December 18, 2015

Re: Application to Amend Alberta Utilities Commission (“Commission”) Southern Alberta Transmission Reinforcement (“SATR”) Needs Identification Document Approval No. U2014-461 (the “SATR NID Approval”)

Figure 3: Medicine Hat Area Transmission System – After the Reconfigured SATR NID Medicine Hat area 138 kV System Reinforcements and the Proposed AI Rothbauer 321S Switching Station Development

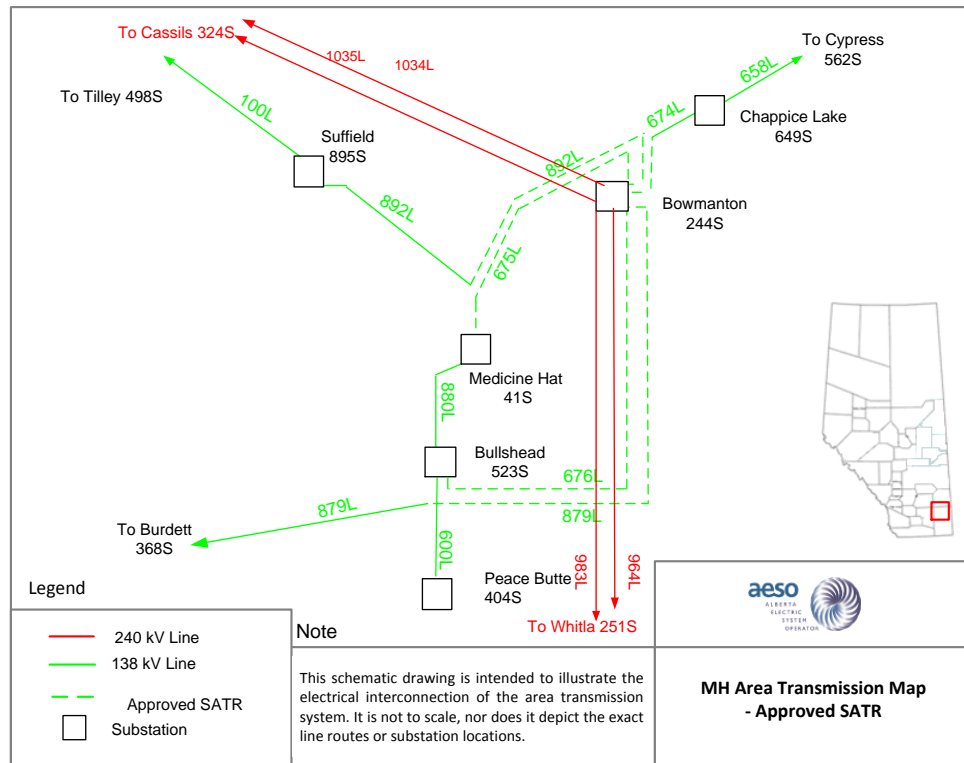
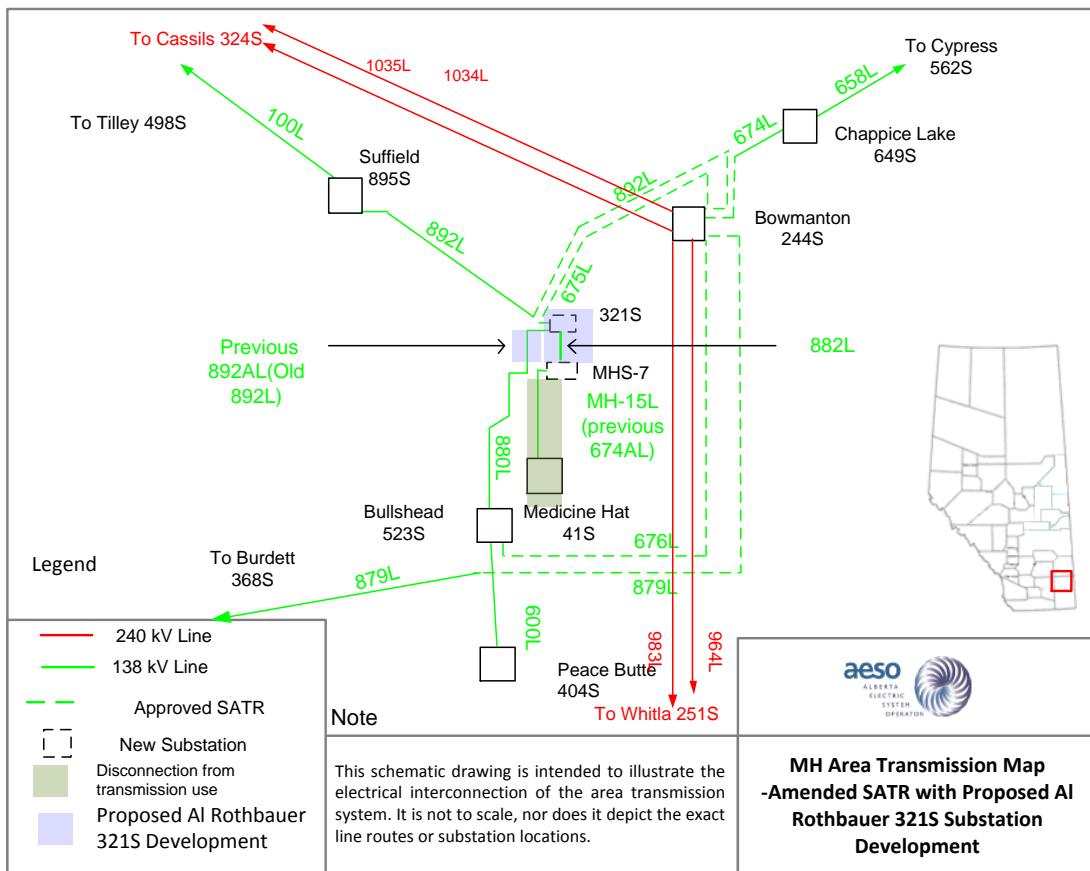
11. For the reasons provided below, the AESO requests that the Commission delete paragraph 8 (a), Stage I of the SATR NID Approval in its entirety and replace it with the following (proposed amendments are shown in bold):

(a) *a new 138-kV transmission line, **designated 675L, from Bowmanton 244S substation to the proposed AI Rothbauer 321S switching station**⁷;*

17. In this Application, the AESO is seeking to amend the SATR NID Approval to reflect the reconfiguration of the 138 kV transmission system in the Medicine Hat area required to enable the AI Rothbauer 321S substation connection. Specifically:⁸

- Prior to completion of the AI Rothbauer 321S substation, the new 138 kV transmission line 675L from the Bowmanton 244S substation will connect to the existing 138 kV transmission line 674L in the vicinity of the proposed AI Rothbauer 321S substation. This interim connection of transmission line 675L is required to maintain connectivity to the existing Medicine Hat 41S substation during construction of the AI Rothbauer 321S substation.

- Upon completion of the AI Rothbauer 321S substation, transmission line 675L will be disconnected from the existing transmission line 674L and terminate at the AI Rothbauer 321S substation. Transmission line 675L will be approximately two kilometres shorter by terminating at the AI Rothbauer 321S substation instead of the Medicine Hat 41S substation, as originally approved.

18. The termination of 138 kV transmission line 675L at the AI Rothbauer 321S substation is addressed by the 321S NID, along with the following:⁹
- Discontinue the Medicine Hat 41S substation from transmission use.
 - Existing transmission line 880L will be disconnected from the Medicine Hat 41S substation and connected to the AI Rothbauer 321S substation to maintain connectivity to the Bullshead 523S substation. The existing transmission line 892L in the vicinity of the Medicine Hat 41S substation that was planned to be removed under the approved SATR configuration, will now be retained and form part of the 138 kV transmission line 880L.
19. Figure 3 shows the Medicine Hat area transmission system following the reconfiguration proposed in this Application and the developments proposed in the 321S NID.
